Transtech ***Bulletin***

Application: General Motors

Subject: 4T80E 1993-Up Valve Body Gasket

TB 14 12/2000

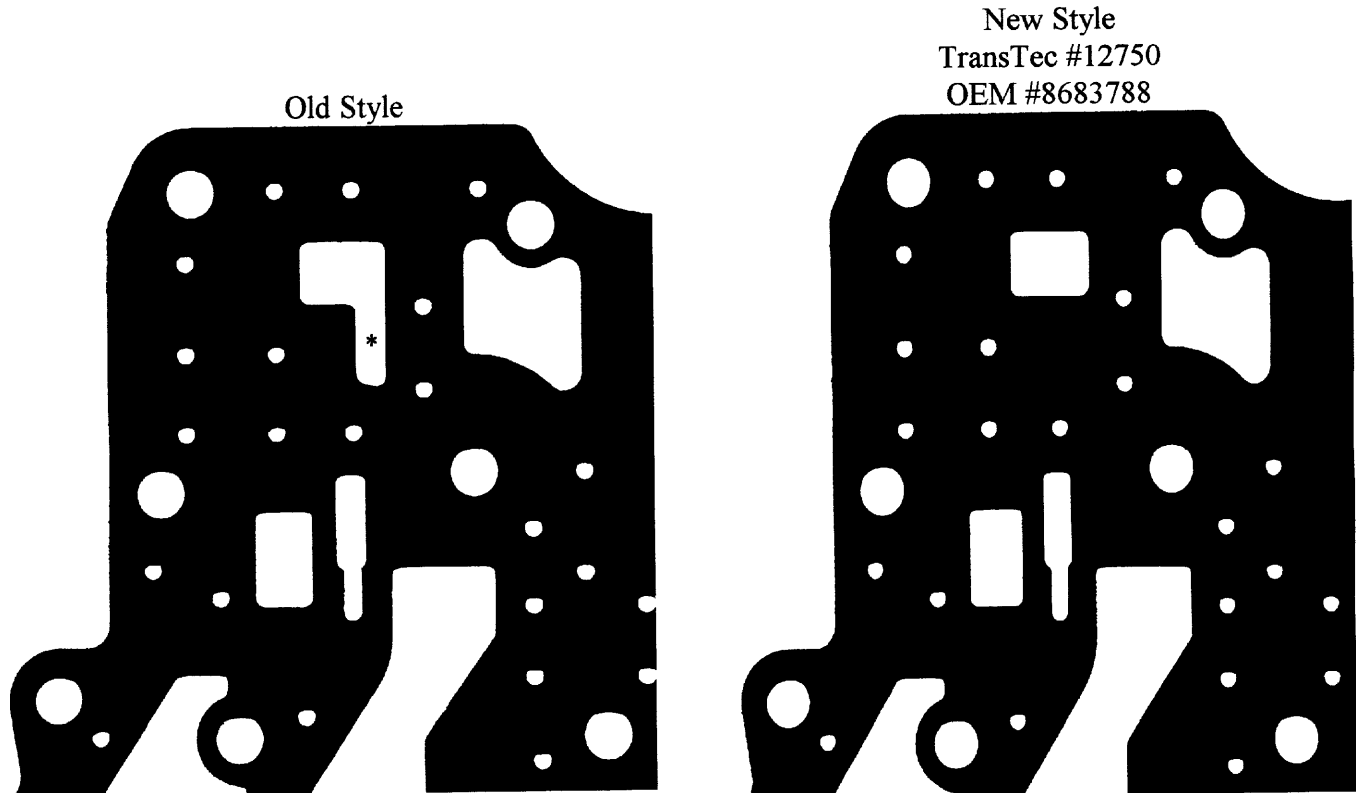
General Motors has altered the hydraulics of the 4T80E slightly for all models from 1993-up. The hatchet passage for line pressure has been modified by removing the handle. With this change, the gasket now matches the separator plate and does not allow line pressure to be orificed into the reverse clutch passage. See the accompanying illustration.

This is a running change by General Motors and will work on all units. The revised gasket has a white ink stripe for additional identification.
